Figure 4
Mapped Area of
Prenda Arroyo
 (Riverside, California Code of Ordinances / Title 17
https://library.municode.com/ca/riverside/codes/code_of_ordinances)
 Alpine Meadows Lane, City of Riverside
 County of Riverside, California

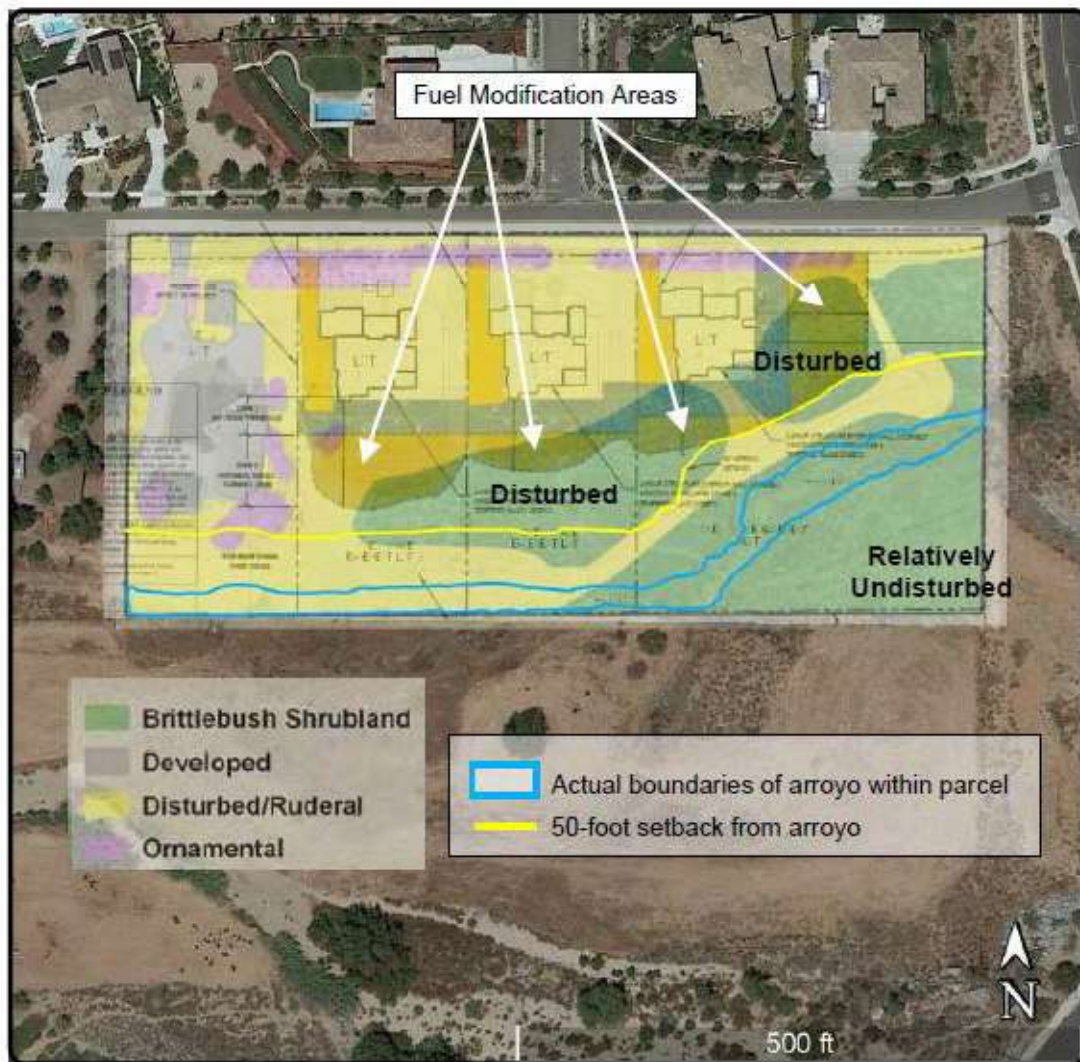
Comment: "Friends of Riverside's Hills is very concerned about protecting the City's designated arroyos, very much including the Prenda Arroyo. The Initial Study for the project says "The project site is largely within the mapped extent of the Prenda Arroyo, as identified in the Riverside Municipal Code (RMC), Title 17 Grading, Exhibits A-F, and is therefore subject to the requirements of the Hillside/Arroyo Grading Ordinance." Actually examination of said Exhibit C appears to show that the project site is all or mostly all entirely well within the mapped portion of the Prenda Arroyo....

Comment: “That means that any consideration of conformity with the Code’s Hillside/Arroyo provisions, by the developer’s consultants or the City Planning Division, may well have ignored the fact that the disturbed area is within the Prenda Arroyo, and thus have been inadequate.”

“As shown in Figure 4, most of the parcel is within the mapped extent of the Prenda Arroyo except for a portion of the northeast quadrant and a small area of the southeast corner.”

Although the project site is within the mapped Prenda Arroyo per RMC Title 17 Exhibit C, it is not within the actual Prenda Arroyo, which is based on in-person assessment of the site and documentation of the current conditions of the site by an experienced biologist. (emphasis added)
